Cory Decarbonisation Project

Responses to Deadline 1 and Deadline 2 submissions on behalf of Landsul Limited and Munster Joinery (U.K.) Limited

Figure 1 – Contextual Indicative Equipment Layout

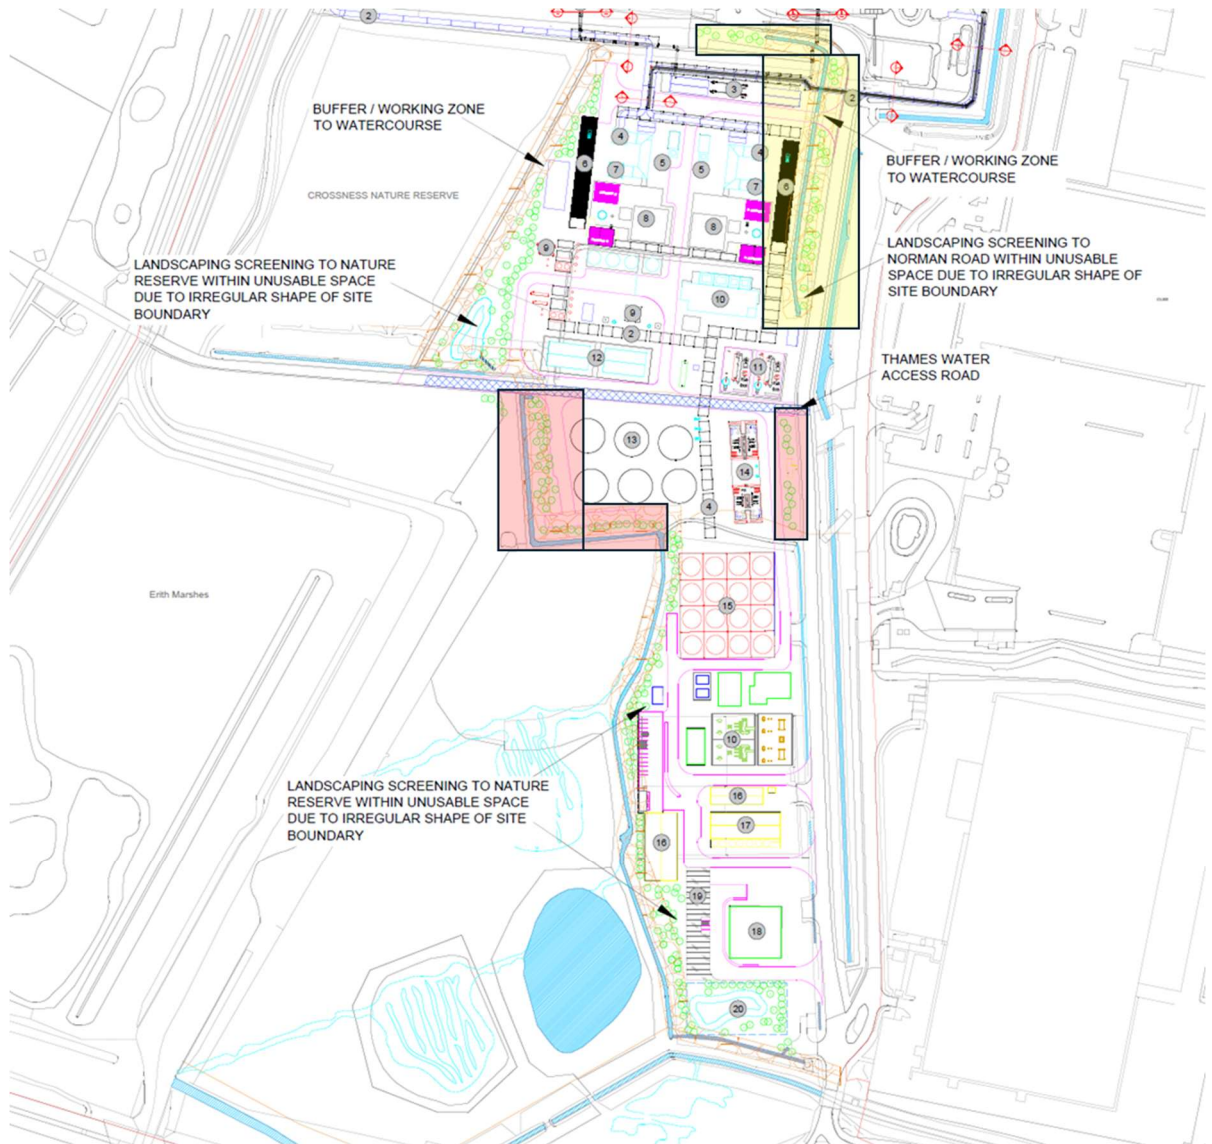
- 4.2 In Figure 1, I have highlighted (yellow and red boxes) a number of areas of planting. As can be seen from the Applicant’s text on the figure, it is contended by the Applicant that (at least for the yellow areas) this is “unusable space due to the irregular shape of site boundary”. I do not agree that this space is irregular – it is actually quite rectangular and would be entirely useable as part of the operational area. It is less clear whether the Applicant also makes this contention for the areas highlighted in the red boxes but, again, I would not consider these spaces either irregular or unusable.

- 4.3 For context, my estimate is that the planting shown in the yellow and red boxes has a footprint of approximately 7,000 m².
- 4.4 It is also important to note that in terms of the planting to west of the northern part of the site, my Alternative Layout would enable very similar planting / screening to what the Applicant proposes. For the planting to the west of the southern part of the site (which is a genuinely irregular shaped boundary) the Alternative Layout again is similar to the Applicant’s scheme and would thus enable similar planting / screening to what the

Figure 3 – Heat load duration curve

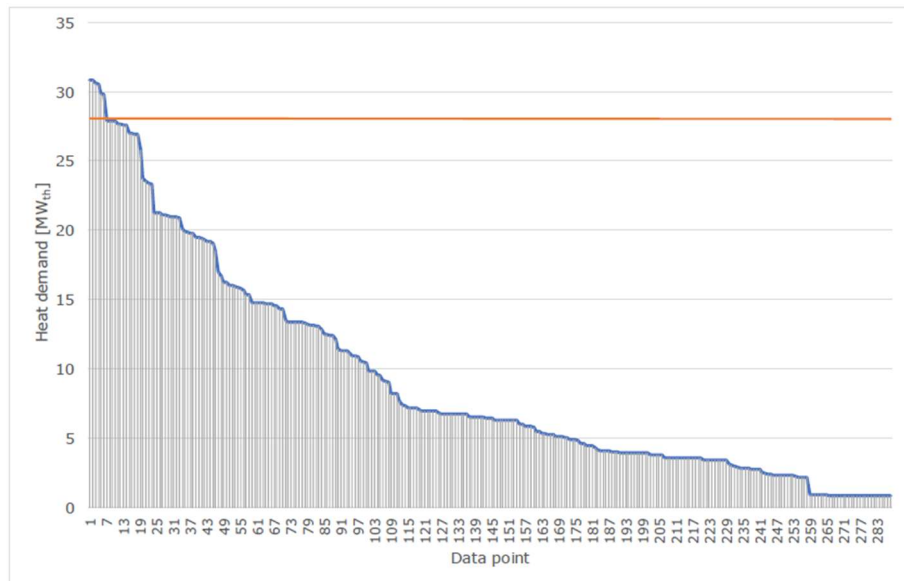
- 4.9 It can be seen that, for the vast majority of the time, the heat that can be exported by Riverside 1 is significantly higher than the demand.
- 4.10 The Applicant suggests that the carbon capture plant will provide 100 MWt^[5] of heat. However, in the context of the report that Cory themselves commissioned, it would appear that there is no identified demand for this heat.

Figure 4 – Applicant's Electrical Distribution Philosophy

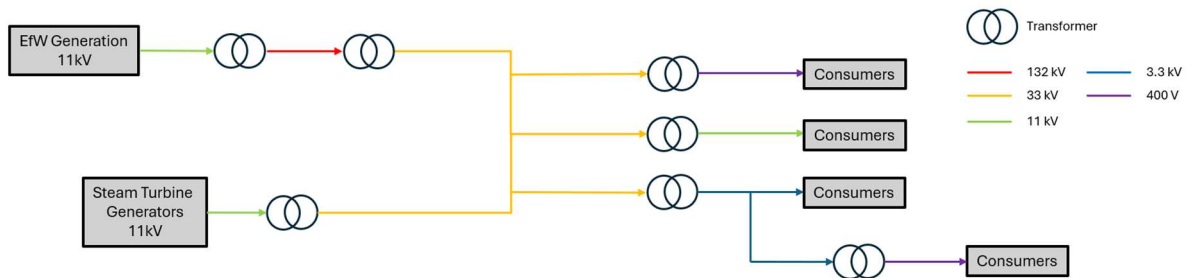
4.24 The design of any electrical distribution system requires the designer to select the most appropriate voltage for distribution. In general, the higher the voltage, the larger and more costly the equipment. However, larger loads require higher voltages and higher voltages also result in lower distribution losses which reduces operating costs. Balancing that however are transformation losses whereby every time the voltage is stepped-up or stepped-down (changed to a lower or higher voltage) losses occur.

4.26 As I have highlighted in my initial report (paragraphs 2.19 to 2.21) the Applicant has included space allowance for a large switchyard as part of the indicative equipment layout. The reason for this switchyard is driven by the electrical distribution philosophy as the use of multiple voltages (in particular the 132kV and 33kV systems) requires significant electrical plant.

- 4.29 It should be recalled that the total electrical load for the carbon capture facility has been confirmed by the Applicant to be 42MWe^[12]. It is clear from Figure 5 above that for a load of this size, 132kV is a very high voltage. In reality, electricity would be supplied by both Riverside 1 and Riverside 2 so each of the two 132kV lines would only be supplying 21MWe peak but for the vast majority of the time, the actual voltage supplied would be zero (assuming the primary generation from the back-pressure steam turbines is sufficient) or less than 5MWe if a small amount of top-up power was required.

- 4.30 It follows that, in my opinion, there is no requirement to distribute electricity from the Riverside 1 and Riverside 2 plants at as high a voltage as 132kV.

Figure 6 - Southern Extent of Applicant's Layout

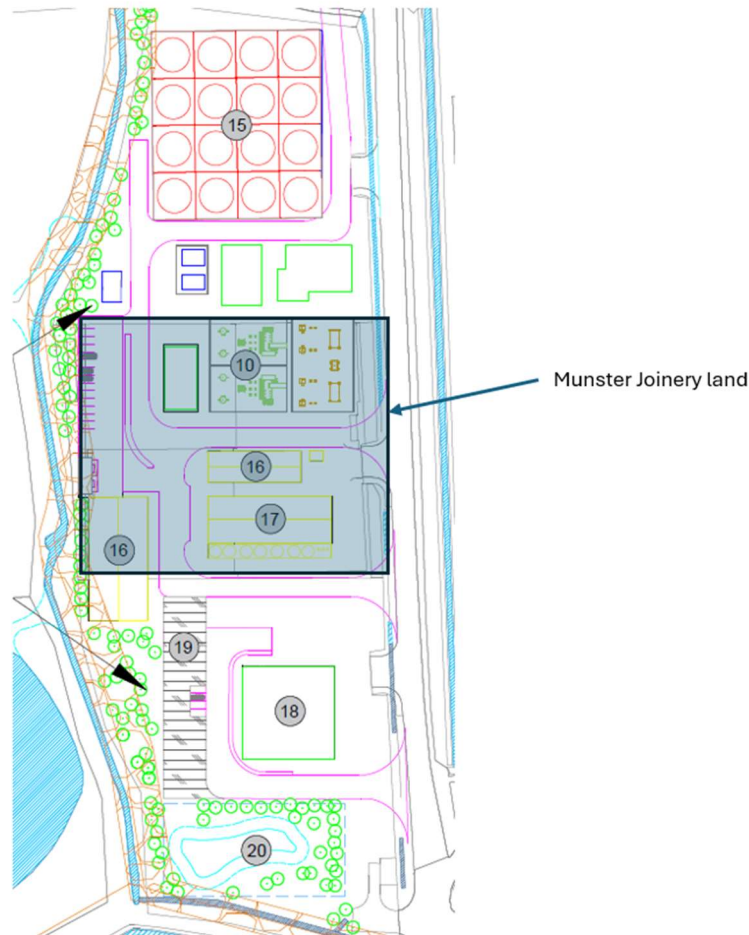
4.41 The table below shows the plant and equipment that, in the Applicant's layout, is accommodated either on the Munster Joinery Land or south of it this along with the required footprint for that equipment.

- 4.43 It is important to note that, because the water storage tank is underground, it would be possible to locate plant or buildings above this provided that suitable manhole access is maintained for maintenance. For instance, in my layout I have included operational laydown above. In contrast, the Applicant has put landscaping / planting above the water tank.

- 4.44 It can be seen from Figure 6 that in terms of the use of the Munster Joinery Land and areas to the south, the Applicant only uses a relatively small amount of this for process equipment. Indeed, of the approximately 19,000 m² of land, the Applicant has used approximately 5,000 m² for planting. There is then 9,000 m² of above ground equipment (counting only the half of the switchyard that is in this area) with the remainder being roads, car parking and additional space.
